35/13-04H 3 West Lenox
Chevy Chase Historic District

MEMORANDUM

HISTORIC PRESERVATION COMMISSION STAFF REPORT

Address:	3 West Lenox Street	Meeting Date:	01/12/05
Applicant:	Cara and Luis Medeiros	Report Date:	01/05/05
Resource:	Contributing Resource Chevy Chase Village Historic District	Public Notice:	12/29/04
Review:	HAWP	Tax Credit:	None
Case Number:	35/13-04H REVISION	Staff:	Anne Fothergill

Medway Residence • South Elevation 2 1/2" x 1'-0" • David Jones Architects 2-9-04 (REVISED 08-JULY-04)

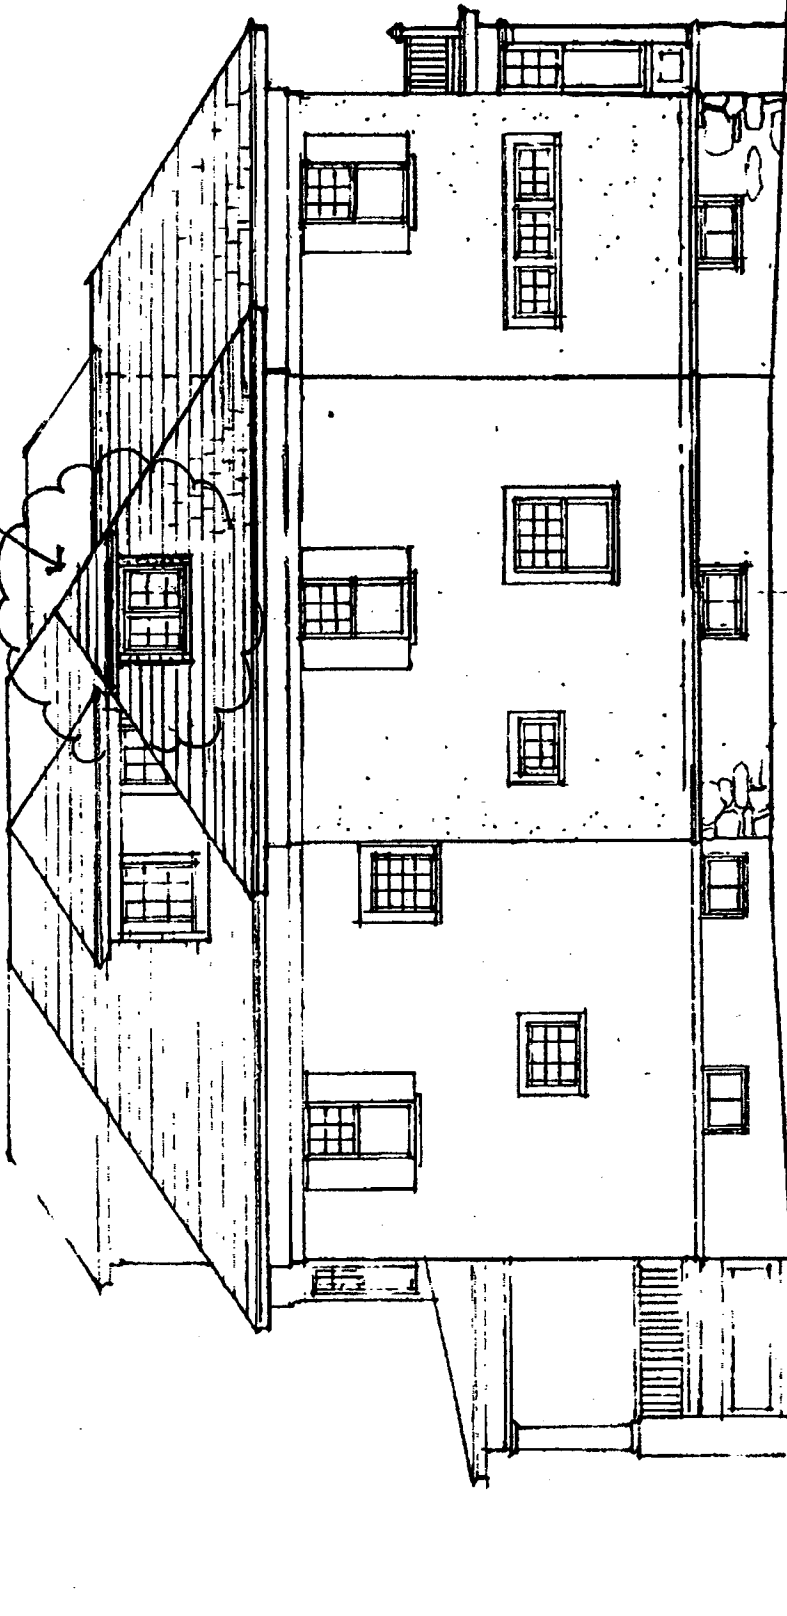
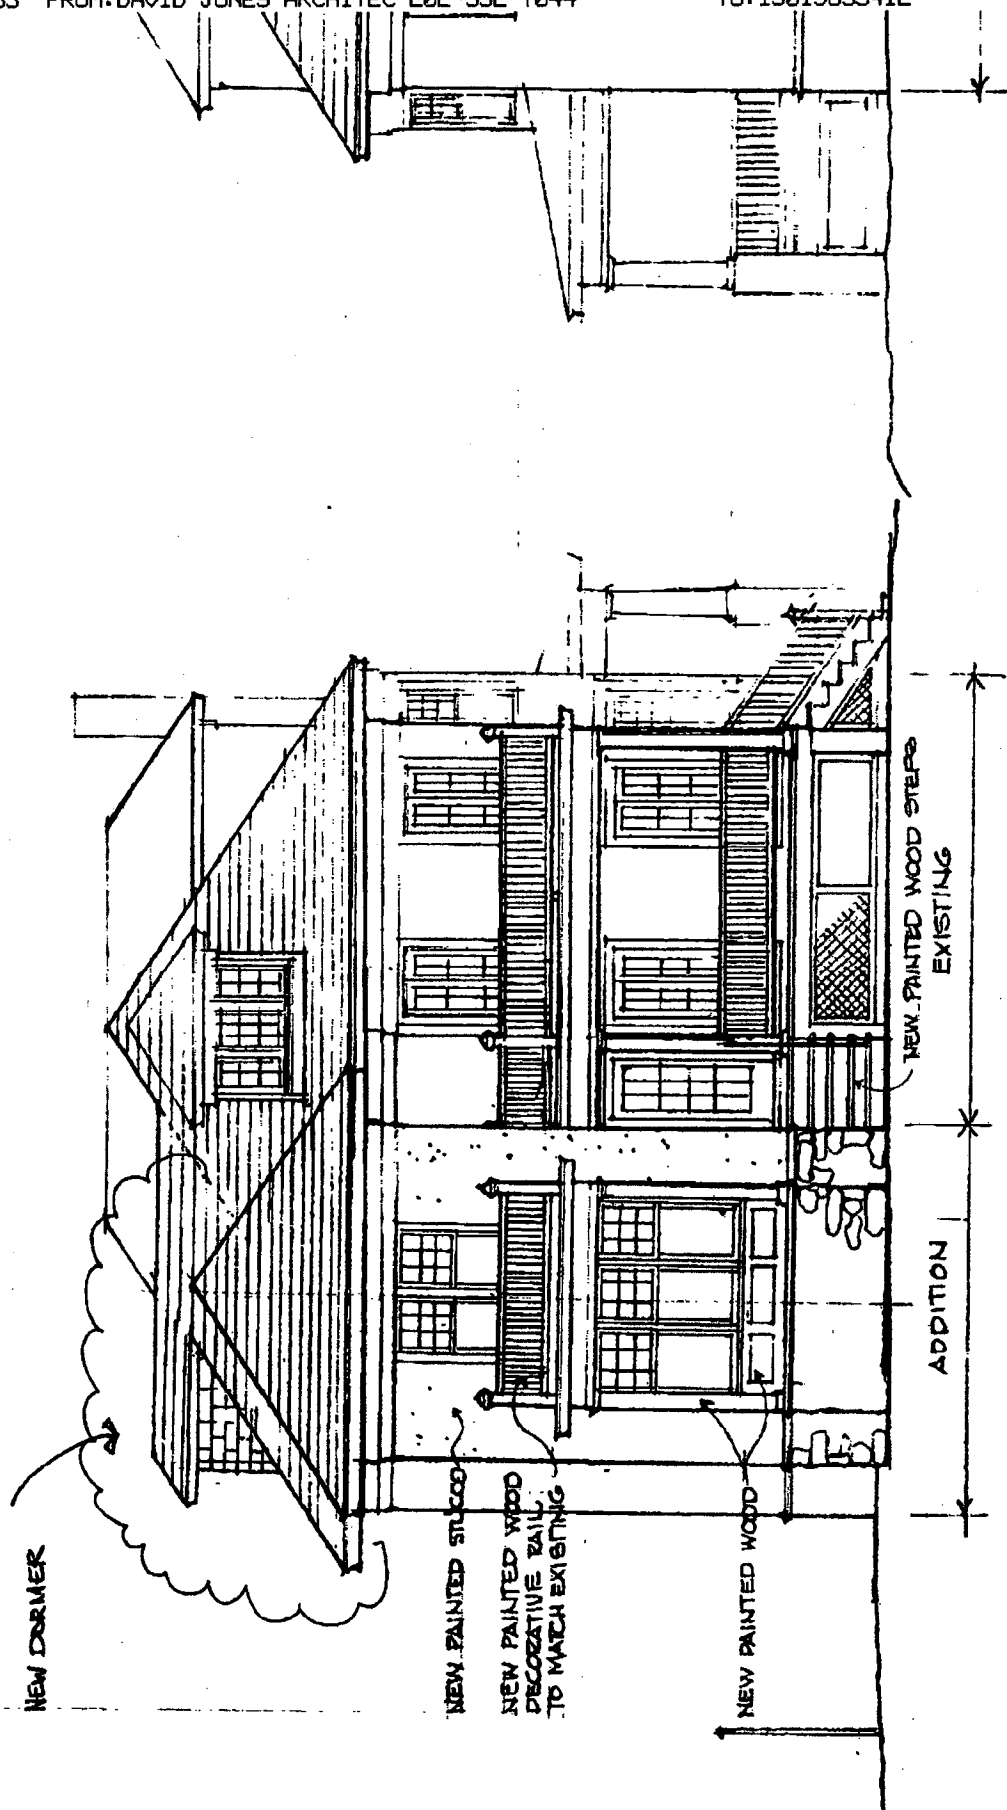
OUR CLIENTS WOULD LIKE TO EXPLORE
THE POSSIBILITY OF EXPANDING THEIR
ATTIC SPACE ALONG WITH THEIR HOUSE
ADDITION, AND THEREFORE, ADDING
A NEW DORMER ABOVE THE KITCHEN
+ MASTER BEDROOM ADDITION.

CAN YOU TELL US IF THIS WOULD BE
ACCEPTABLE (SEE ATTACHED) OR, IF
WE WOULD NEED TO PRESENT THIS TO
THE COMMISSION?

At the March 10, 2004 HPC meeting, the HPC approved an addition to 3 West Lenox Street in Chevy Chase. The applicants now want to add a new dormer to the new addition section at the rear right side of the house. The proposed new design and what was approved in March are attached.

Staff recommendation: Approval

Staff would like the HPC's approval for staff-level approval of these changes.

50 Residence • Site Plan @ 1/16"=1'-0" • David Jones Architects 2.9.04

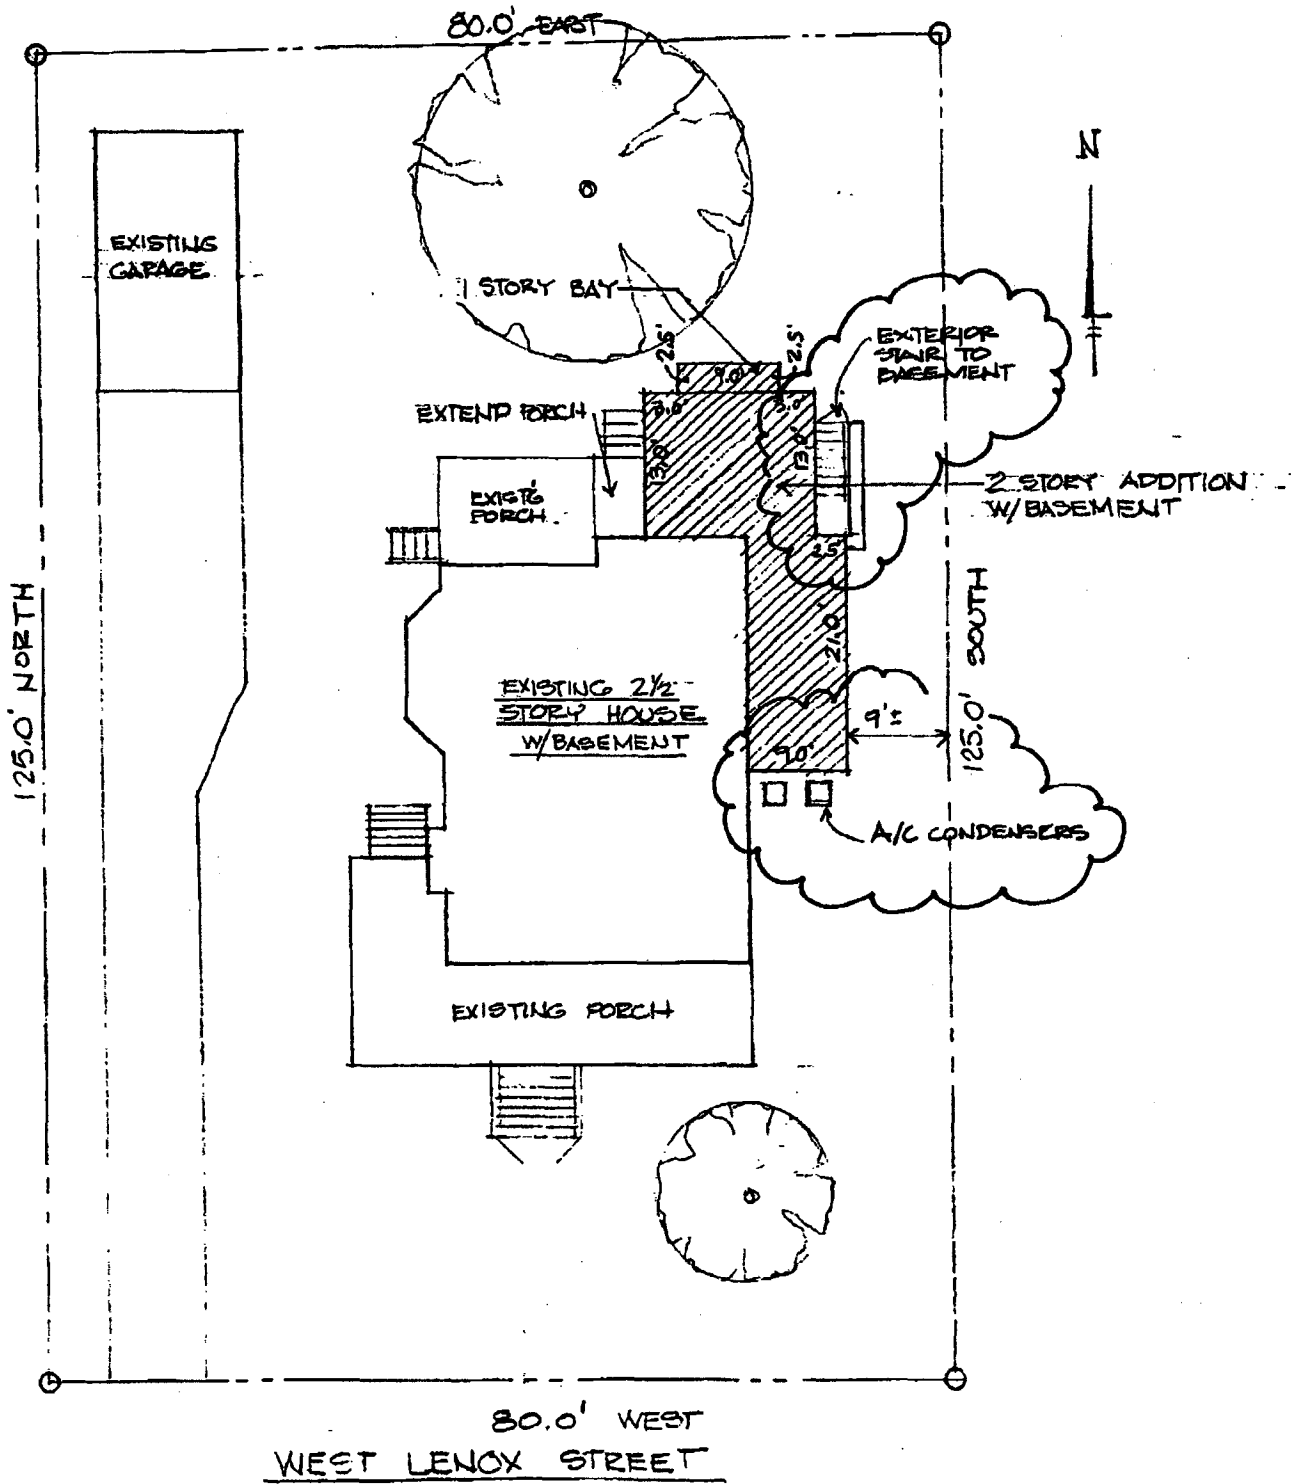
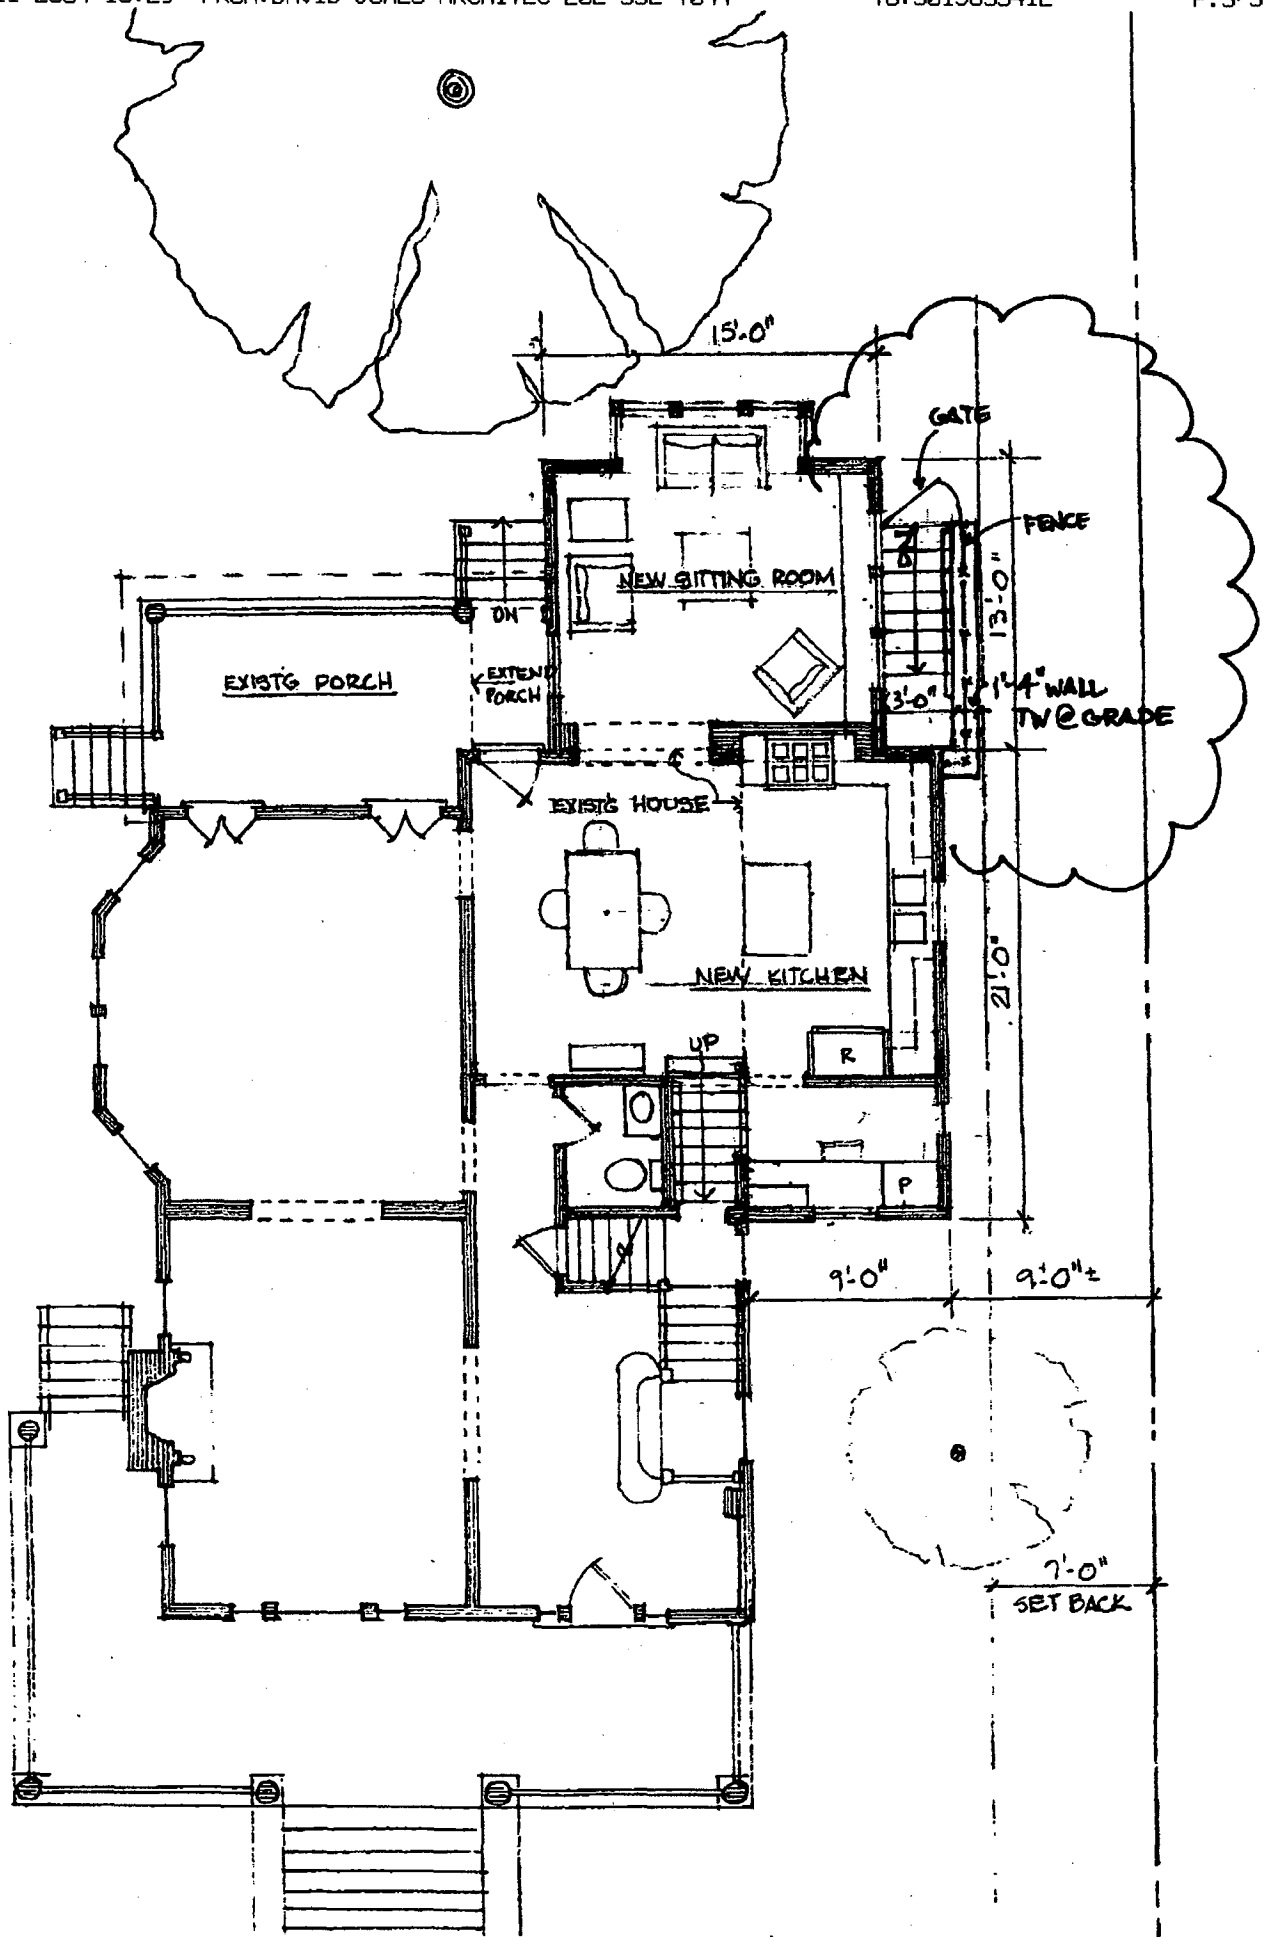
REGARDING CARA MEDEIRO'S EMAIL TO
YOU ON 4.26.04, ATTACHED IS A SITE
PLAN AND FLOOR PLAN INDICATING THE
PROPOSED BASEMENT STAIR.
PLEASE CALL ME TO DISCUSS THIS.
